Circuit Analysis Report

Test IC	ATmega128RFA1	
Crystal	Holder	NX3225SA
	Frequency	16.000MHz
	Load capacitance	CL=8pF[IEC] (Current) CL=10pF[IEC] (Suggested)
	NDK Spec. No.	STD-CSR-6(J) (*J:CL=10pF[IEC])
Test Circuit	IC	MEGA128RFA1-ZU 1105D 0T6227
	VDD	+3V / +1.8V
	PCB	TB2-MEGA_RF AVR2067 - Crystal Characterization for AVR RF

2. CIRCUIT DIAGRAM

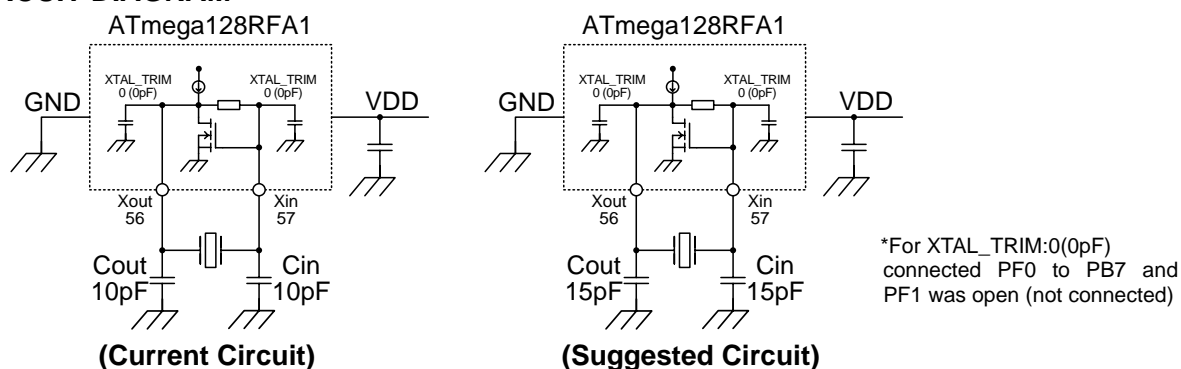
- 1) This crystal unit requires negative resistance of $-R = 800\Omega$ minimum for stable oscillation
- 2) Circuit characteristics

- 3) Although the negative resistance of the current circuit is over our target, it seems too large.
- 4) In order to improve negative resistance, we recommend changing external capacitance values from Cout/Cin=10pF/10F to **Cout/Cin=15pF/15pF**. Besides, we recommend changing crystal load capacitance value from CL=8pF to **CL=10pF** in order to improve frequency deviation.

Circuit	Cout/Cin	XTAL_TRIM (Internal Cap)	Frequency deviation dF/F	Negative Resistance -R	Drive Level DL	Startup time Tstr
Current	10pF/10pF	0 (0pF)	+6ppm (CL=8pF[IEC])	3220 Ω	Less than 10uW	2ms
Suggested	15pF/15pF	0 (0pF)	-2ppm (CL=10pF[IEC]) Ref.: -27ppm (CL=8pF[IEC])	1970 Ω	Less than 10uW	2.5ms
